SUBJECT: Process Control Adjustment

PDC10E

SUBJECT: Exposure Glass Removal

SUBJECT: Interface Kit Type B CE Mark Compliance

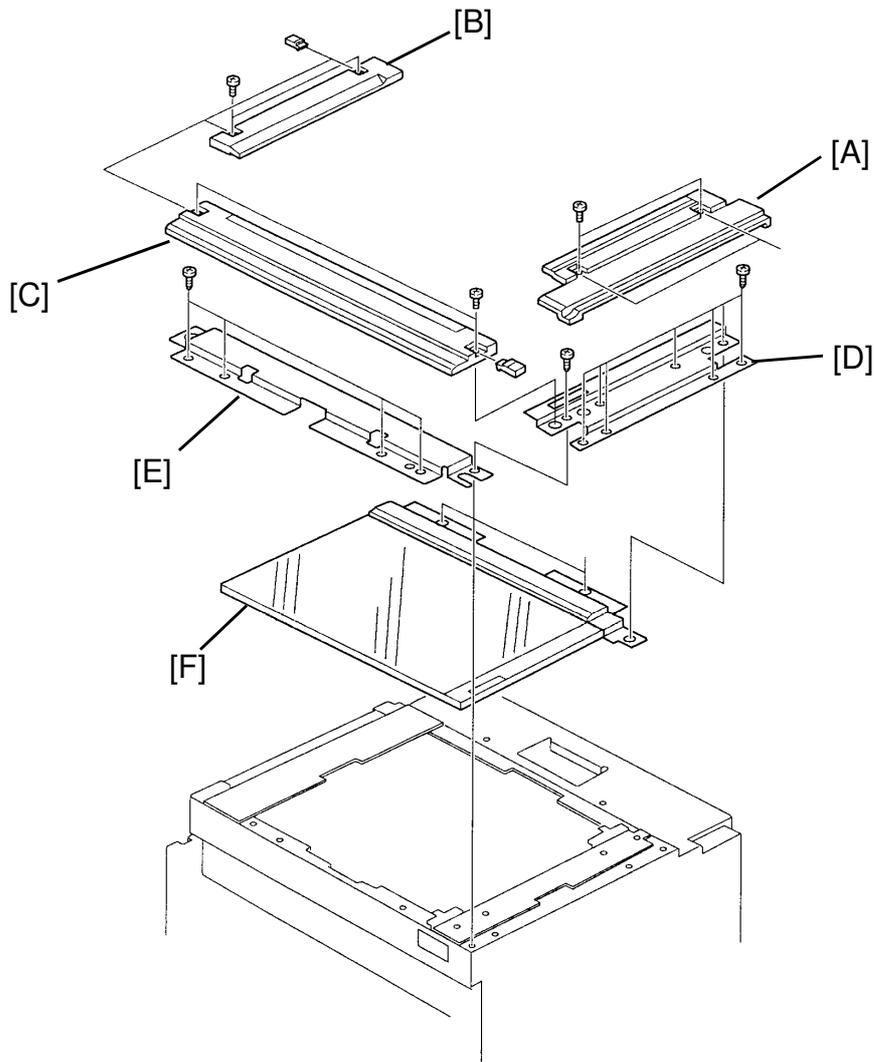
To comply with the CE mark standards, the edges of the exposure glass have been covered with copper plates. These plates will reduce the amount of electrical noise emitted from the copier.

Due to this modification, the exposure glass removal procedure has been changed as follows.

1. Remove the top left cover (4 screws).
2. Remove the screw covers (6 pcs.) from the right, left, and front scales.
3. Remove the right [A] and the left scale [B] (2 screws each).
4. Open the front covers and remove the toner tank unit (2 screws).
5. Remove the operation panel (5 screws and 2 connectors).
6. Remove the front scale [C] (2 screws).
7. Remove the right spacer [D] (8 screws).
8. Remove the front spacer [E] (4 screws).
9. Remove the exposure glass [F] (2 screws).

1. The front scale is clamped to the exposure glass, so when reinstalling the exposure glass make sure that the front scale clamp is properly set on the glass.
2. The right spacer, the front spacer, and the exposure glass are secured with M3x4 screws. Make sure not to use longer screws, since scanner movement may be obstructed.

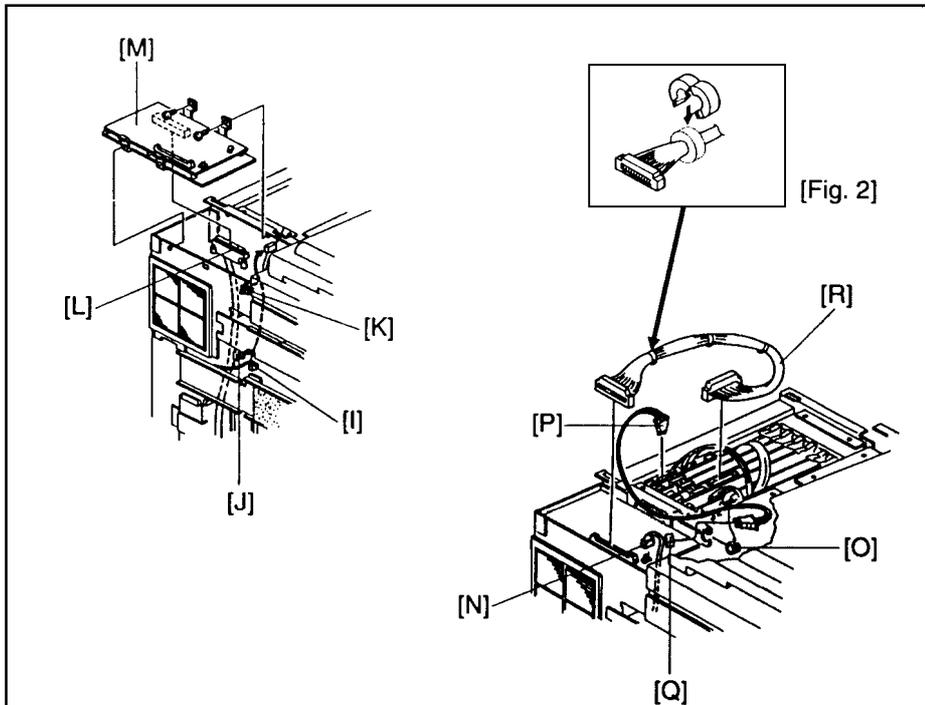
3. Open the process control board bracket [A] (2 screws).
4. Route the controller interface harness [B] as shown in the diagram (2 screws - M4 x 6).
5. Secure the grounding wire [C] to the rear frame (M4 x 8).

6. Remove the cooling fan bracket [D] and route the controller interface harness upwards.
7. Install the gray ferrite core around the controller interface harness and secure the core with the harness band as shown [Fig. 1].

8. Remove the PCB cover [G] (11 screws) .
9. Flip the white hooks on the side of the System Control Board [H] and remove the board (3 optical fiber connectors and 1 connector).

10. Replace the 5 ROMs on the System Control Board (IC145, 146, 147, 148, and 149). See the below table.

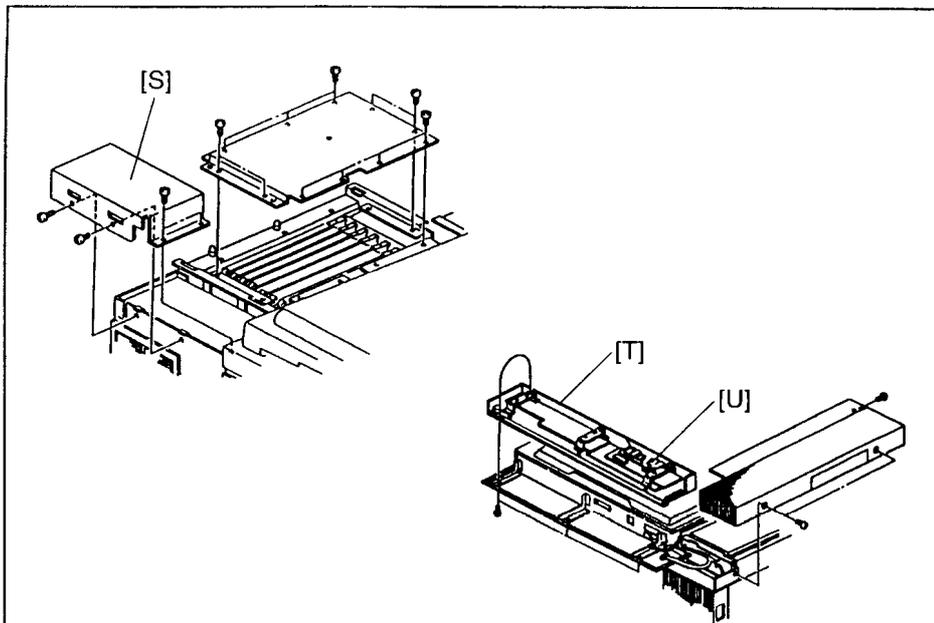
12. Take the DC harness connector (4p) [I] from the clamp [J].

NOTE: The harness connector [I] has 2 brown wires and one red wire and it is coiled around the clamp [J].

13. Route the DC harness [I] up through the connector clamp [K].
14. Connect the interface harness [L] to CN102 on the interface board [M] and secure it (2 screws).
15. Install the interface board assembly [M] on the main frame (2 screws - M4 x 6).
16. Connect the DC harness [N] to CN103 on the interface board.
17. Remove the bushing [O] from the right rear upper side of the main frame.
18. Connect the fiber optics cable [P] to CN108 on the system Control Board and to CN101 [Q] on the interface board through the bushing [O].
19. Connect the interface harness [R] to CN125 on the System Control Board and to CN100 on the interface board through the bushing [O].
20. Install the white ferrite core around the interface harness [R]. (See [Fig. 2])

NOTE: Ensure the ferrite core is placed on the harness so that it will be enclosed by the reinstalled interface board cover.
